Intersection ID: 12687	Main Street: BROWNING_AV	Cross Street: NASSAU_BV	Location:	SE
ADA ID: EC975779B2CE	Ramp Type: Perp	Initial Pass/Fail: Fail	Overall Compliance: No	Severity Score: 21.25

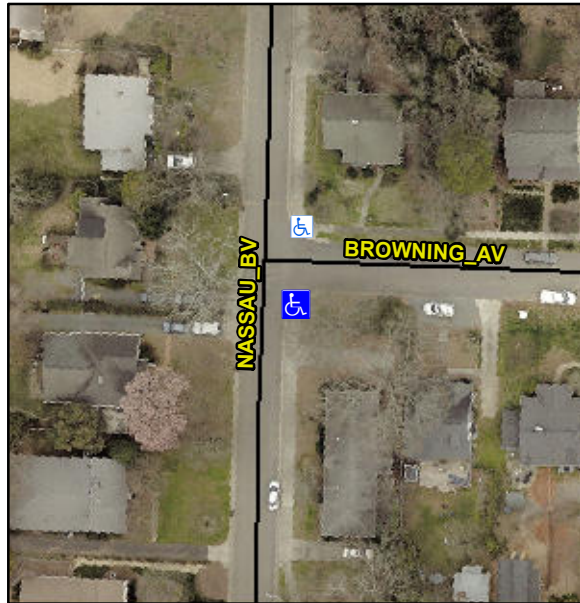
Not Found, R304.5.1, R304.5.3

Remove & Replace Entire Ramp.
